S E R V I C E N O T E

4957A Protocol Analyzer

PC Assy/04957-66503/66504/66505/66506/U30

Modification to Stop Monitoring and/or Simulating

Fig. 1

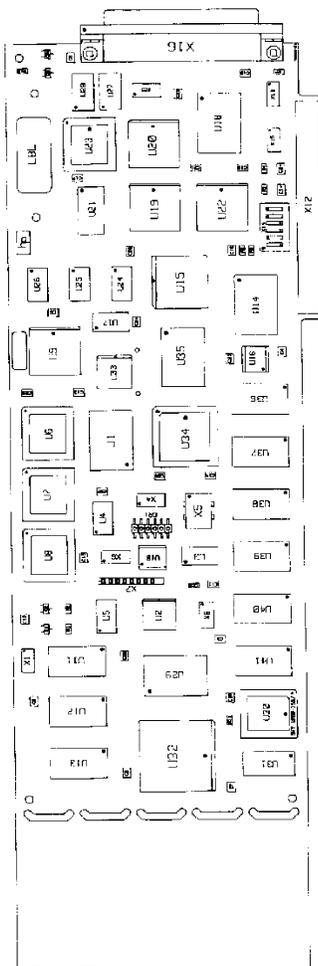
The 4957PC has a problem working with the 18281A ISDN Basic Rate Interface. The problem occurs when using the 4957PC/18281A in a monitor or simulate run mode. The monitoring or simulating can be started, but can not be stopped by pressing the EXIT key. The only method of stopping the monitoring or simulating process is by cycling the power to the card.

The ROM, U30, has been reprogrammed to fix this run mode problem. Using Figure #1, remove ROM U30, located in the lower left corner of the board, from its socket. The present part number will be either 04957-19007 or 04957-19015. Place the new ROM, p/n 04957-19034, in the socket. Place the PC card into a computer and run the HPTools application. At the top level menu of the 4957PC, press <MORE> and enter the Self Test menu. Run the self test loop to verify the operations of the card.
